Reyburn & Bryant

Hillcrest & Donald Road

Lot 1 DP 43502 Lot 3 DP 155118

TITLE
 CURRENT TITLE SITUATION
 PROPOSED SUBDIVISION
 OF LOT 1 DP 43502 &
 LOT 3 DP 115118

DATE	MAY 2026	SCALE	1:2500 @A3
NO.	S17700	SHEET	1/4
		REV.	E

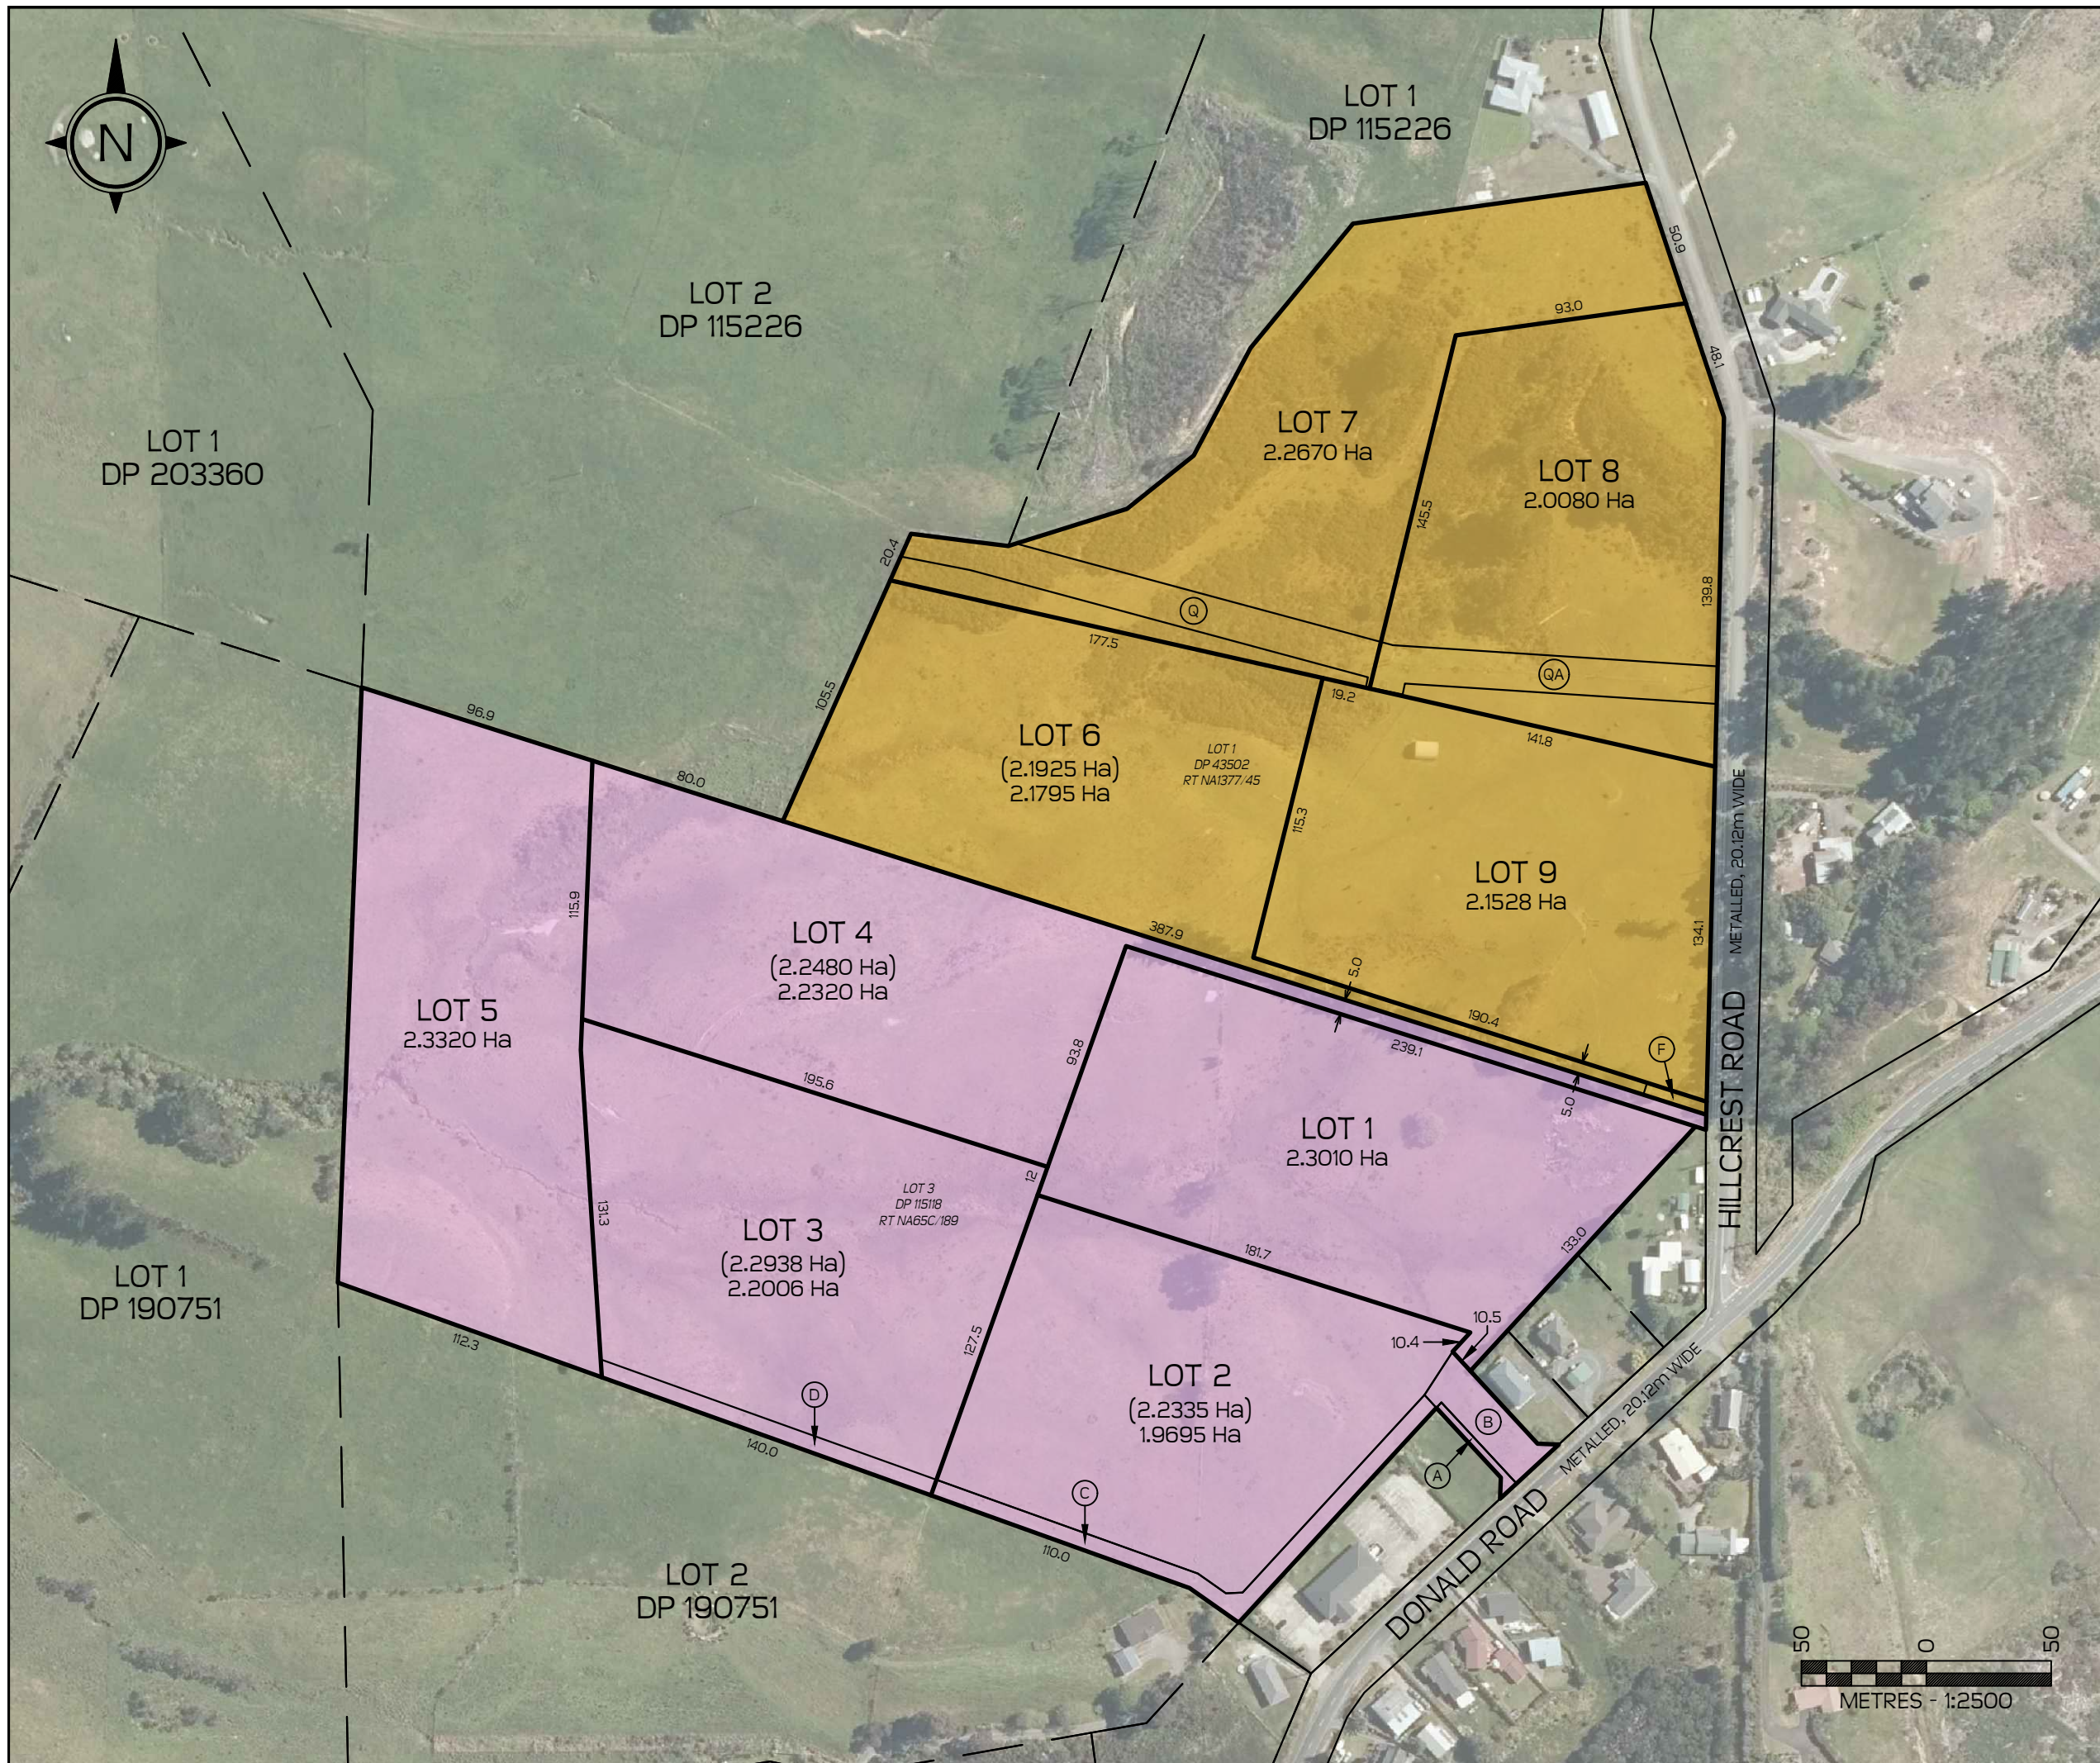
6. **Stage 1:**
 - Creation of Lots 6, 7, 8, and 9.
 - Establishment of Right of Way 'F' to provide legal access to Lots 6 and 9.
 7. **Stage 2:**
 - Creation of Lots 1, 2, 3, 4, and 5.

- Establishment of Rights of Way 'B', 'C' and 'D' to provide legal access to Lots 1, 2, 3 and 5.
8. An amended scheme plan (Rev D) is **enclosed**.
9. In addition to the staging above, changes are also proposed to the access arrangements associated with Lots 1, 4, 6 and 9, where:

- Lot 1 will instead be accessed from right of way 'B'.
 - Lot 4 will be accessed via an individual pan-handle driveway.
 - Lots 6 and 9 will share an accessway shown on the scheme plan as right of way 'F'.

REV	DATE	DESCRIPTION
E	01.05.26	REMOVING ROW E - SN/KM
D	03.03.26	STAGING - JBH/KM
A	09.08.23	FIRST ISSUE - JBH/TM

DATE	AUGUST 2024	SCALE	1:2500 @A3
NO.	S17700	SHEET	1/1 Rev. C

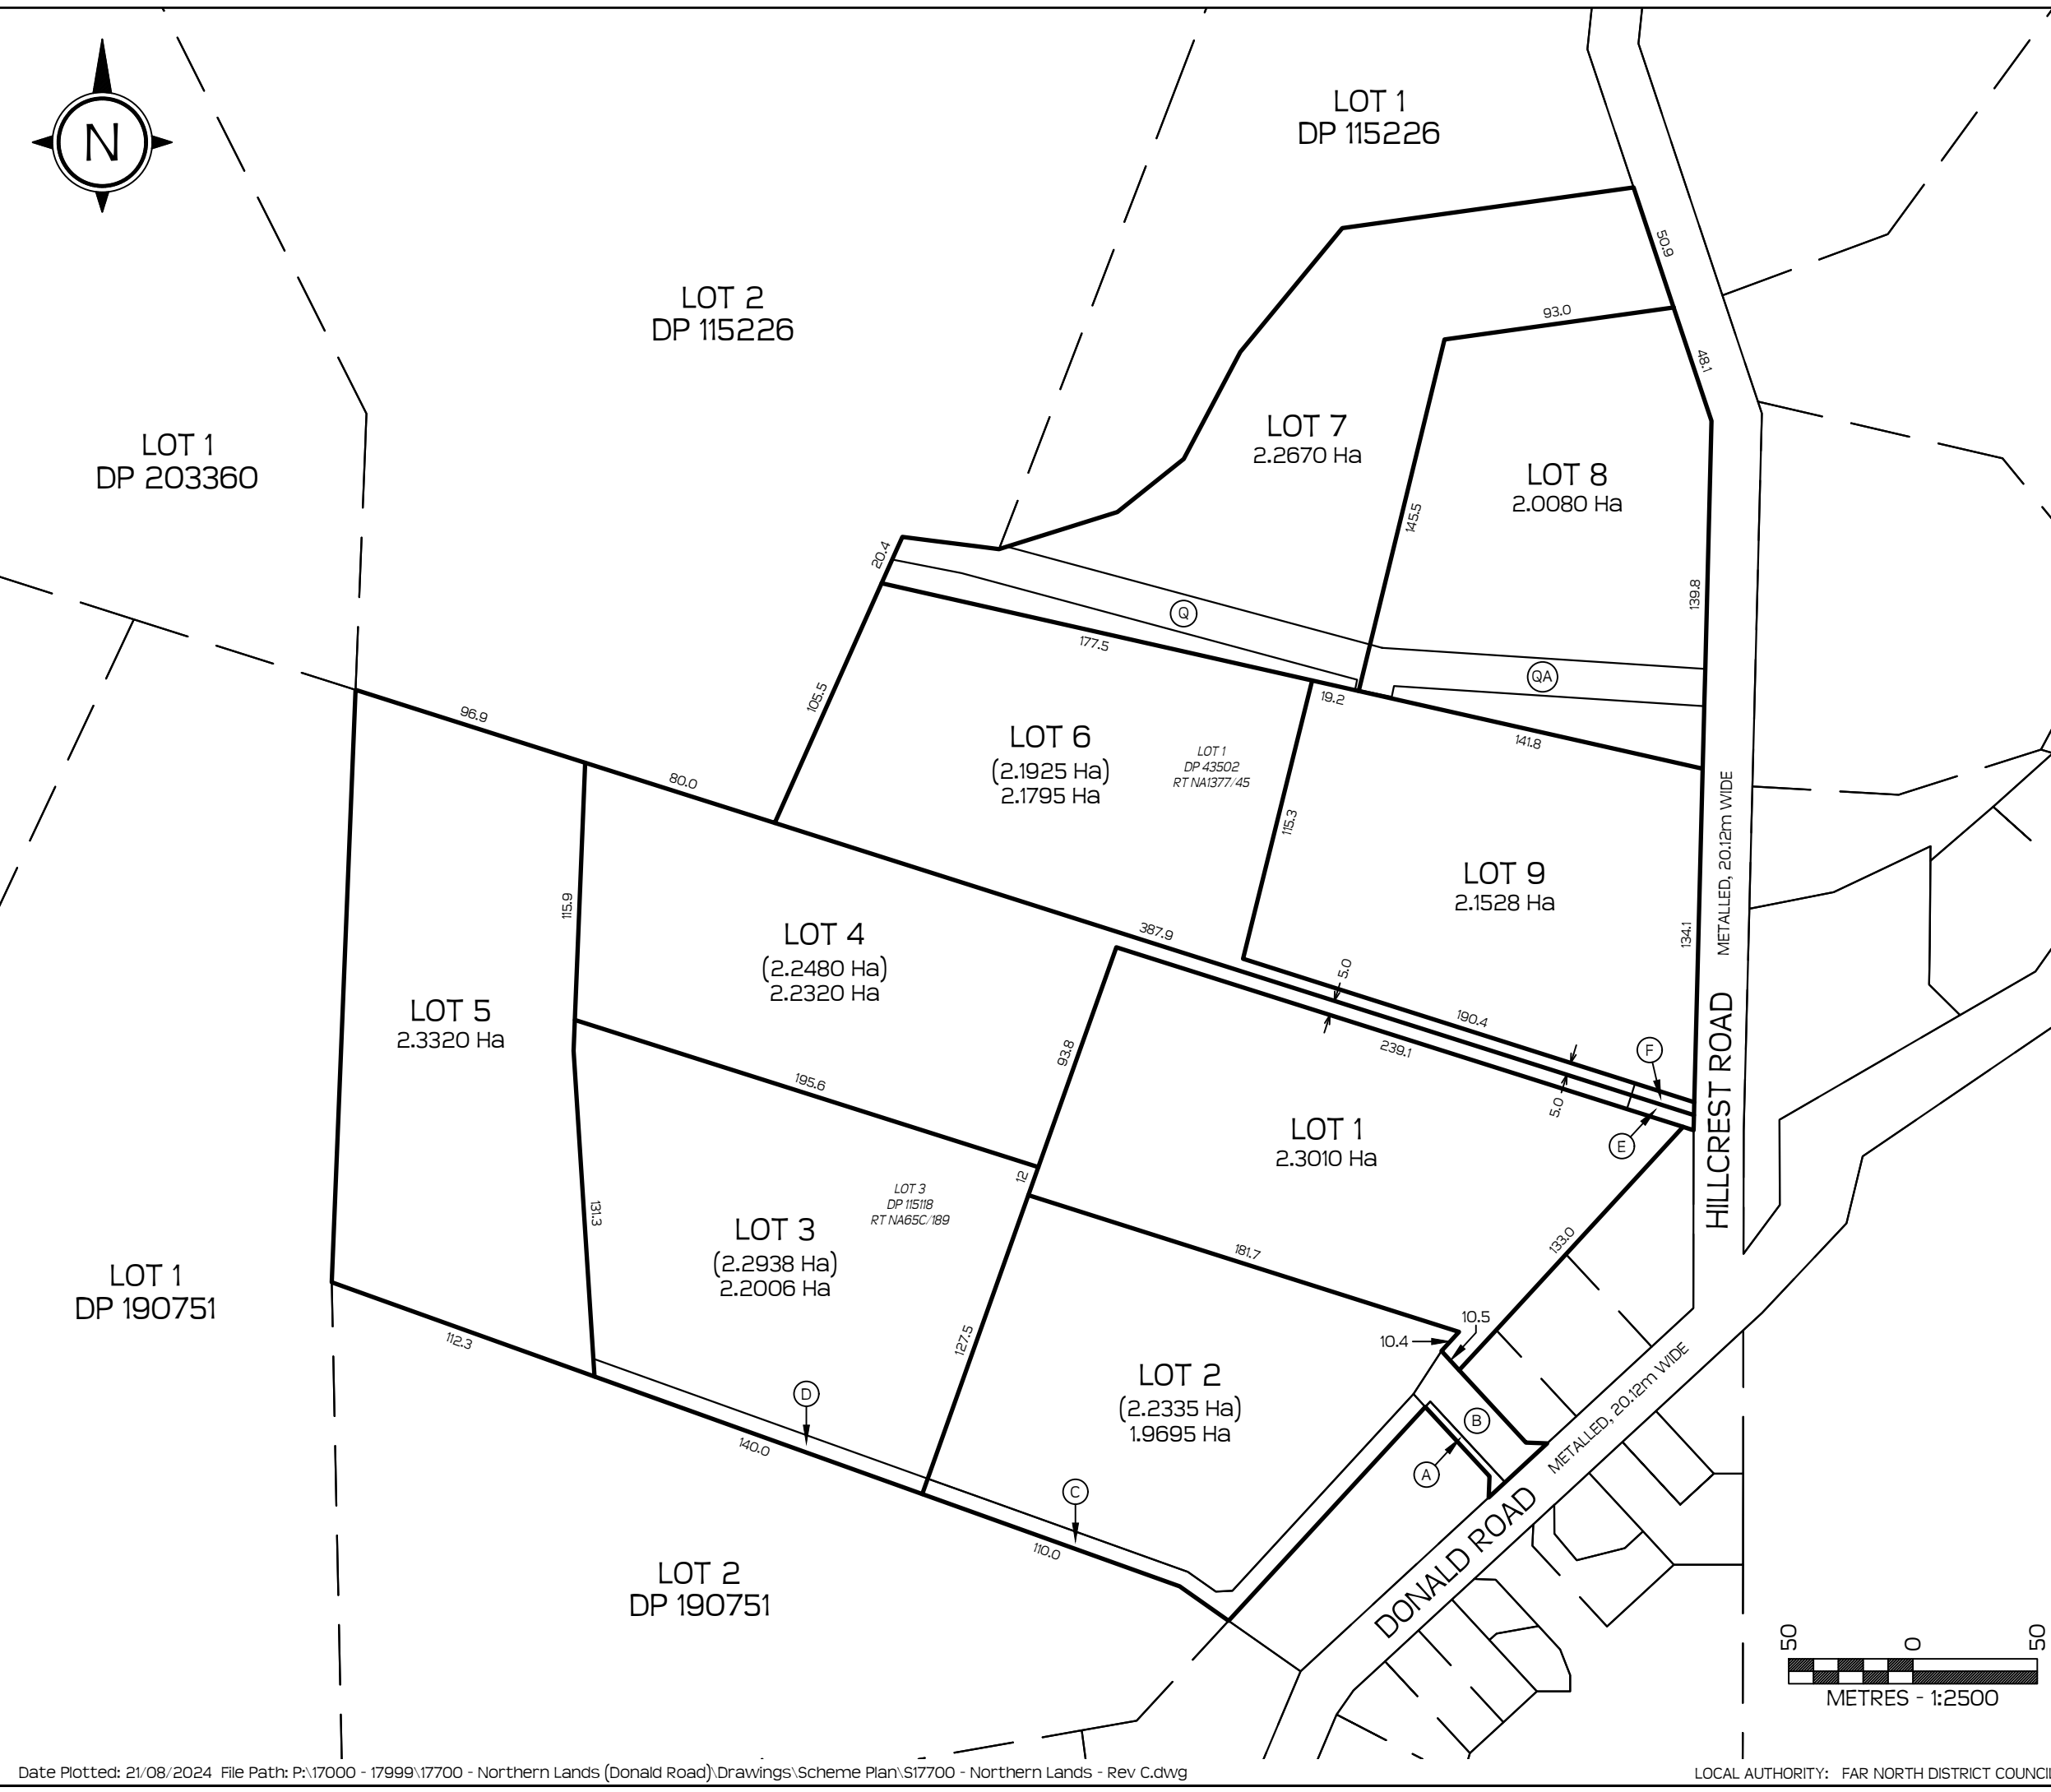
1. The subdivision shall be carried out in accordance with the approved plan of subdivision prepared by Reyburn & Bryant, titled 'Proposed Subdivision of Lot 1 DP 43502 & Lot 3 DP 115118', referenced S17700, REV C, dated August 2024 and attached to this consent with the Council's "Approved Stamp" affixed to them.
